Access Compliance Report

Public Rights-of-Way

(Curb Ramps)

Intersection ID: 43360	Main Street: HIGHLAND_COMMONS_RD	Cross Street: RIDGEVIEW_COMMONS_DR	Location: S
ADA ID: 45A67CA432F5	Ramp Type: PerpDiag	Initial Pass/Fail: Fail	Overall Compliance: No
Severity Score: 1.25			
Codes/Mitigation Info/Possible Solution		Field Measurements/Component Compliance

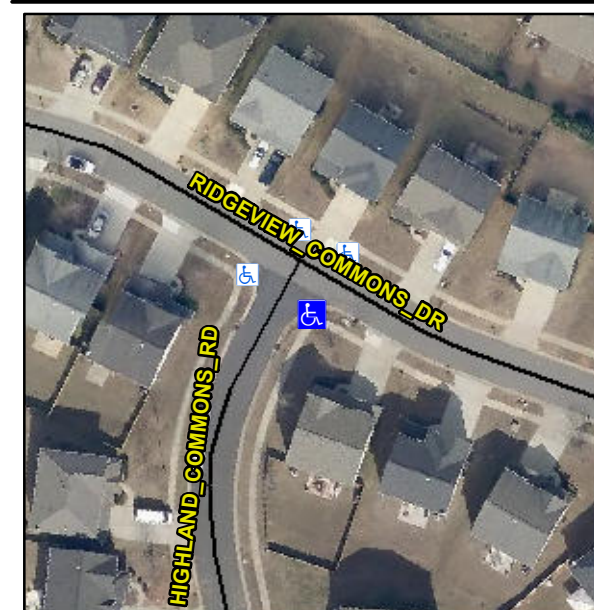
Not Found, R304.5.3

Compliance	Description	Data	Compliance	Description	Data
N/A	Ramp Length (in)	58.0	Yes	Ramp Slope (%)	5.4
Yes	Ramp Width (in)	48.0	No	Ramp XSlope (%)	3.8
N/A	Flare Type LT	N/A	N/A	Flare Type RT	N/A
N/A	Flare Slope LT (%)	N/A	N/A	Flare Slope RT (%)	N/A
N/A	Flare Traversable LT?	N/A	N/A	Flare Traversable RT?	N/A
N/A	Landing Length (in)	N/A	N/A	DWS Provided?	N/A
N/A	Landing Width (in)	N/A	N/A	DWS Contrast?	N/A
N/A	Landing Slope (%)	N/A	N/A	DWS Length (in)	N/A
N/A	Landing X Slope (%)	N/A	N/A	DWS Full Width?	N/A
N/A	Landing Curb? (Y/N)	N/A	N/A	DWS Offset (in)	N/A
N/A	Shared Landing?	N/A			
N/A	Gutter Ponding?	N/A	N/A	Gutter Slope (%)	N/A
N/A	Gutter Lip Ht (in)	N/A	N/A	Gutter X Slope (%)	N/A
N/A	Painted X Walk1?	No	N/A	Painted X Walk2?	No
	X Walk 1 Direction	To NE		X Walk 2 Direction	To NW
N/A	X Walk 1 Width (in)	N/A	N/A	X Walk 2 Width (in)	N/A
	X Walk 1 Slope (%)	2.3		X Walk 2 Slope (%)	0.3
	X Walk 1 X Slope (%)	0.7		X Walk 2 X Slope (%)	2.7

Remove & Replace Curb Ramp With Two New Directional Ramps or Equivalent.
